DRURY MANAGED FILL – REQUEST FOR INFORMATION

1 I write on behalf of Scarbro Environmental Limited (**Scarbro**) in reply to your letter of 6 March 2026 which requested information, in relation to the Drury Managed Fill application for referral by the Minister, under section 20 of the Fast-track Approvals Act 2024 (the **Act**):

is the Drury Managed Fill project reliant on upgrades to Hunua Road being completed and, if so, when are these upgrades intended to be delivered and by whom (including who will provide the funding).

Figure 1: Freight route classification as per 2024 TIA (pre 17 December 2025)

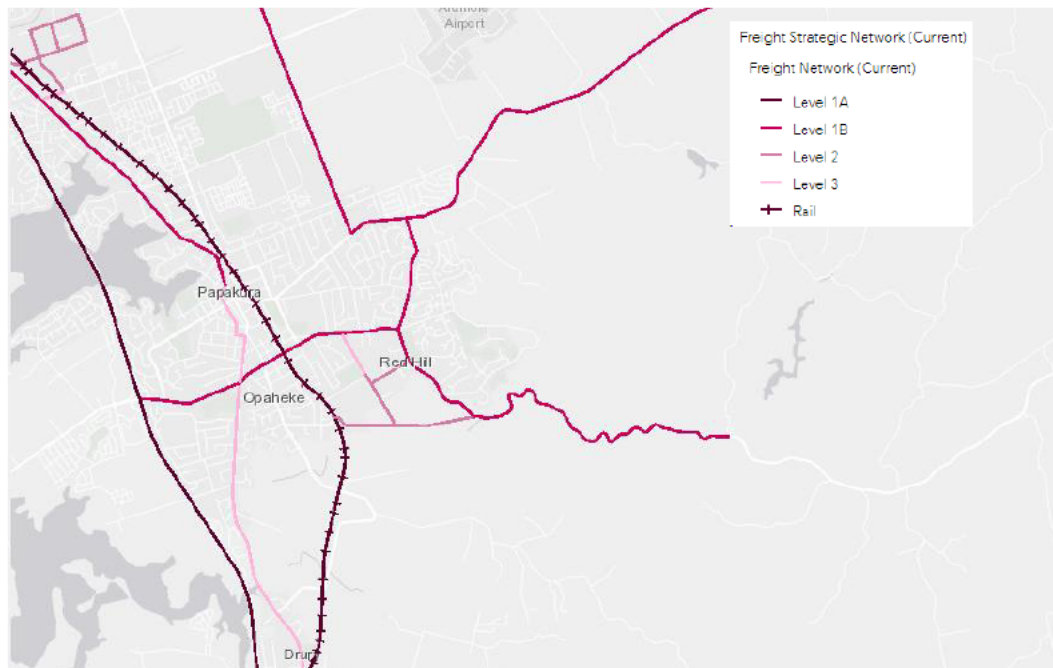
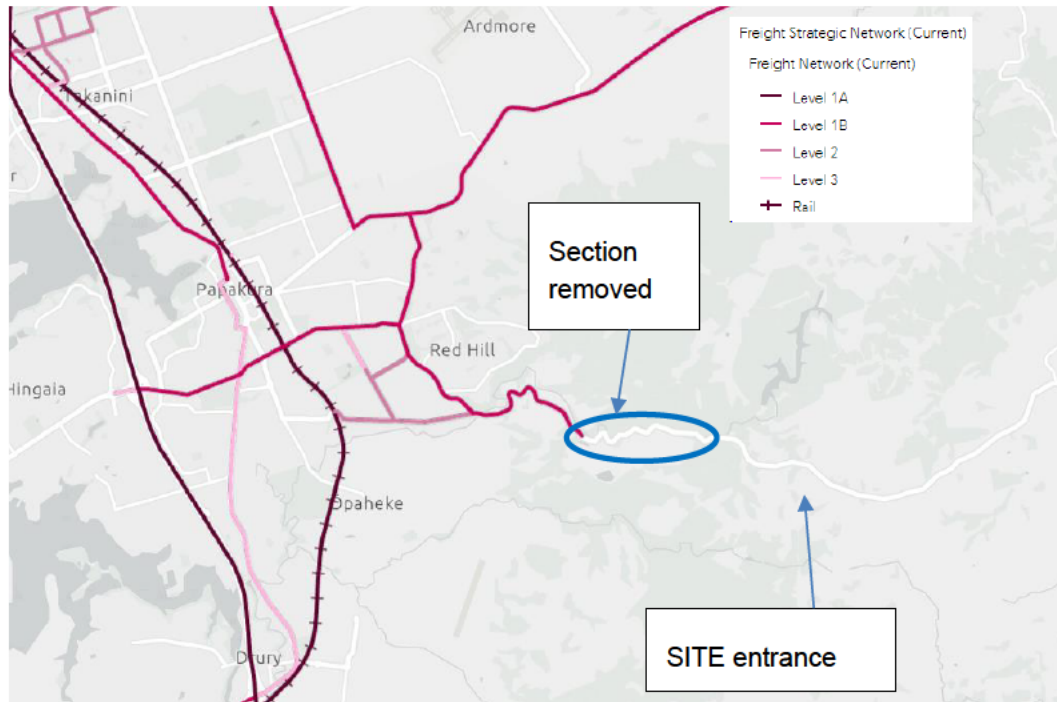
- 33 The change in status is only of very small section of Hunua Road which includes all four of the narrow sections that were identified by Leo Hills as in need of further mitigation measures to meet the required standard.²⁴ That is the only change within a 10km radius.²⁵
- 34 In addition, the Key Section of Hunua Road was removed from the freight strategic network entirely rather than being downgraded from level 1B to level 2 or 3.
- 35 The change is detailed in the diagrams below, prepared by Leo Hills:²⁶

Figure 2: Freight route classification (post 17 December 2025)
